Urgent Field Safety Notice
Product Correction
 Urgent - Immediate Action Required

Date Issued September 16, 2019

Abbott has identified a potential reliability issue with the Alinity ci-series Level Sensor, Bulk Solution (LN 04S68-02). The details of the issue and the potential impact is described below.

Figure 1. Examples of cracked level sensor (Not Acceptable)

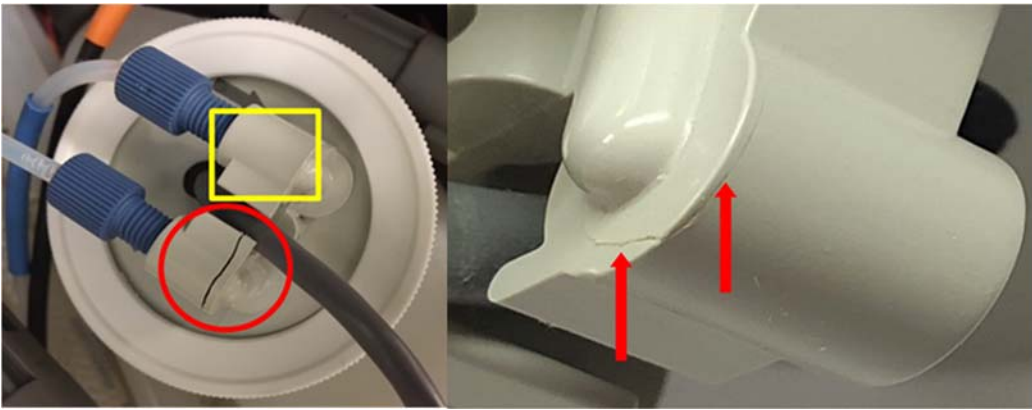
- Crack size and location on inlet and outlet ports is variable. See Figure 1.
 - On each level sensor, there is a “knit” line that is a normal outcome from the manufacturing process. The “knit” line is not a crack or defect in the level sensor. See Figure 2.
4. If crack(s) are detected,
 - Replace the bulk level sensor. LN 04S68-02 may be used until LN 04S68-03 is available. For replacement instructions, refer to the Alinity ci-series Operations Manual, Section 9.
 - Review results generated from the last successful quality control.
 5. When the inspection is complete slide the reservoir bottle tray into the bulk solution reservoir area and close the bulk solution door.

- Area in red circle indicates level sensor crack.
- Area in yellow square indicates undamaged port.
- Area with red arrows indicates cracks.

Figure 3. Identification of the Level Sensor, Bulk Solution (LNs 04S68-02 and 04S68-03)

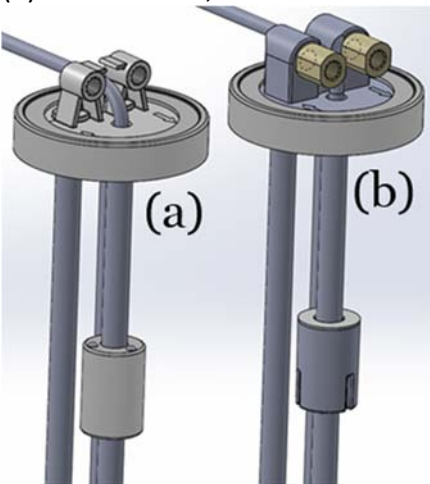
Abbott has redesigned Level Sensor, Bulk Solution (LN 04S68-02) to improve reliability. The redesigned Level Sensor, Bulk Solution (LN 04S68-03) will be available beginning in the fourth quarter of 2019. You may continue to run the system using part number (LN 04S68-02) until the replacement parts (LN 04S68-03) are obtained by taking the recommended actions outlined in this letter. Once the redesigned Level Sensor, Bulk Solution (LN 04S68-03) is available, Abbott recommends the replacement of the LN 04S68-02 in all positions on the Alinity c and i systems.

(a) Level Sensor, Bulk Solution LN 04S68-02, (b) Level Sensor, Bulk Solution LN 04S68-03
